# SERVICE BULLETIN

**Number:** SB0503

**Subject:** Deck Lift Rod Assembly for 52K23X

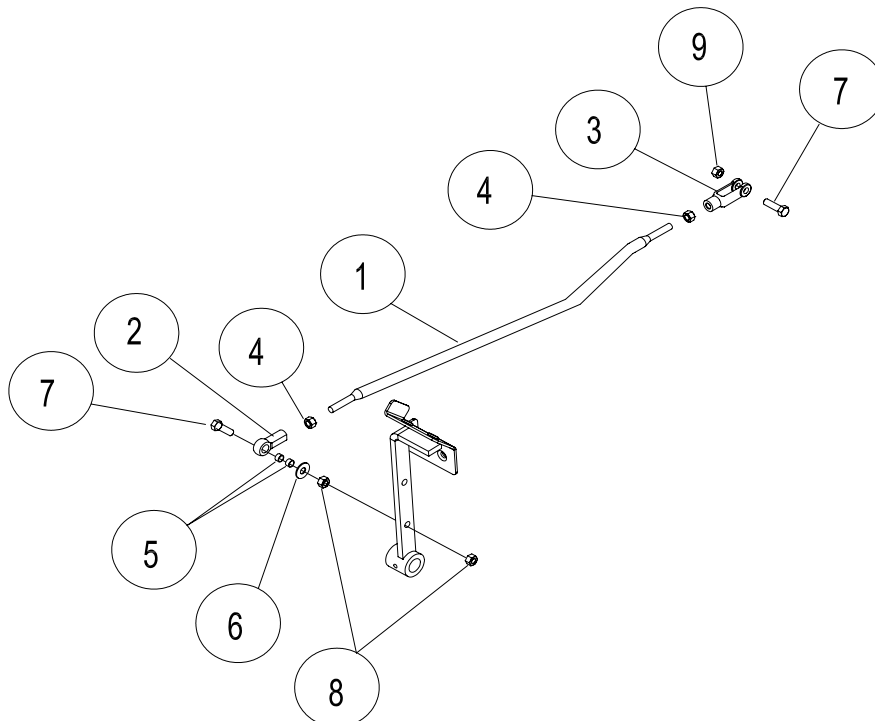
**Details:** The deck lift rod assembly for the Encore X-treme 52K23X has been changed on units with serial # 50242 and above. The complete assembly now consists of the following components:

Following is the required hardware for fastening the deck lift rod assembly to the unit:

When installing the lift rod assembly, make certain that the bend in the rod is pointed downward toward the deck in order to prevent the rod from interfering with the height adjustment pin.

Please make note of these changes in your 52 X-treme illustrated parts manual.
